Service Bulletin Mazda North American Operations

SEAT SHAKES BACK AND FORTH / MAKES NOISE WHEN BRAKING

Bulletin No: 09-061/09

RX-8, Mazda5 & Mazda6 [with pantograph type seat lifter (A)]:

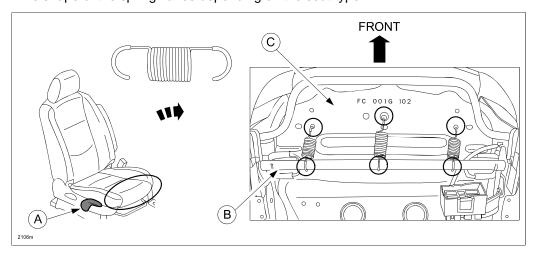
Some vehicles may exhibit a seat that shakes back and forth and is noisy during braking.

- 1. Verify customer complaint.
- 2. Install three (3) springs to the back of the seat cushion seat pan (C) and pipe frame (B).

NOTE: The shape of the spring varies depending on the seat type.
